Attached with this letter is a copy of the site plan for lot 25 in WynnrIDGE Subdivision showing a revised drain field layout. This layout reflects the required minimum (50 ft.) buffer from the well on the adjoining lot which, was not identified during the initial investigations.

Project: Lot 25 Wynnfield  
 Client: On Top Builders  
 CAD File: Wynnridge  
 Scale: 1" = 50'  
 Date: October 3, 2019

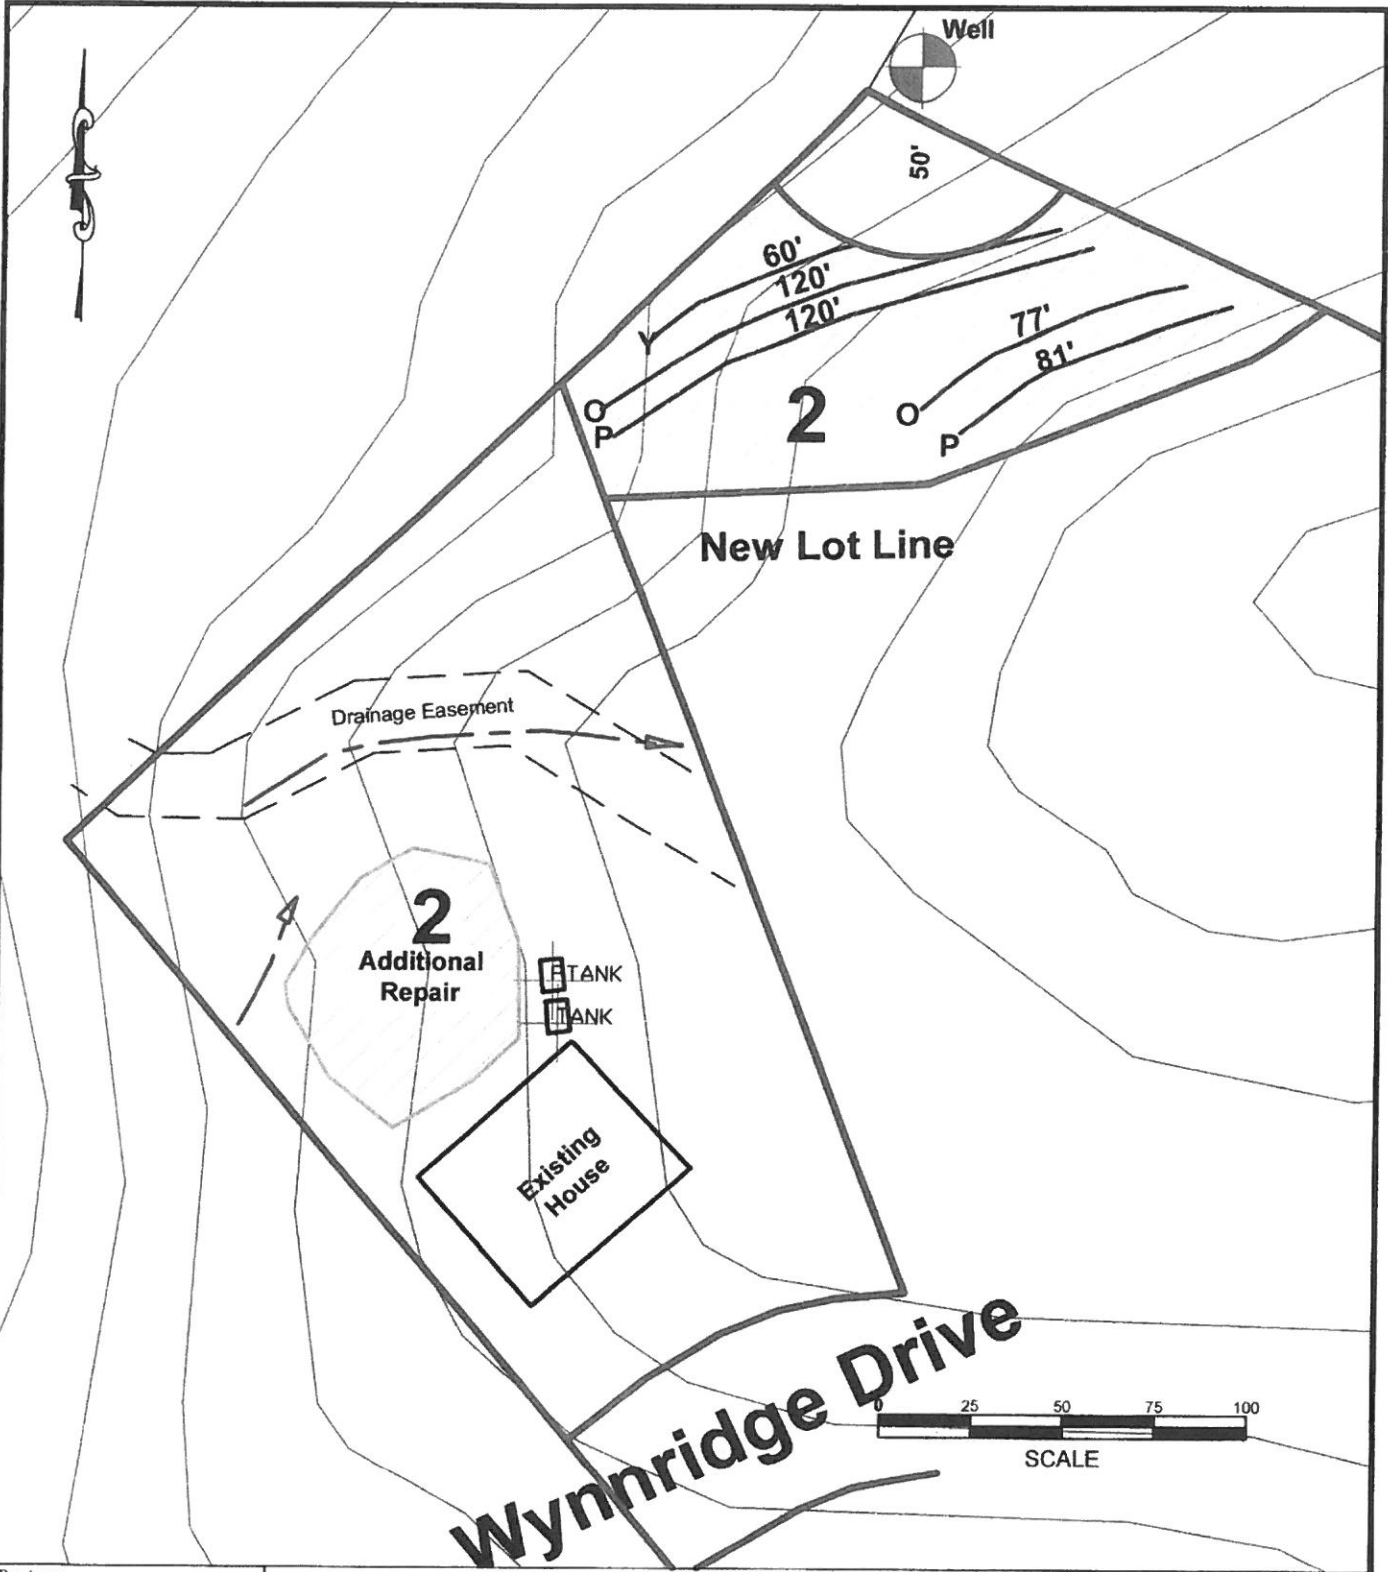
A 2 X 120' initial system is presently proposed. Using a chamber system for a 25 percent reduction in trench requirements. This trench system can be recommended based on the original LTAR of 0.50 to 0.45 for the site (as shown on the tap chart). Approximately 218 linear ft. of trench remains for a repair system, which should be sufficient given the LTAR. Please note that there is additional repair area available immediately behind the house as shown on the sketch map. The LTAR for this area ranges from 0.35 to 0.40.
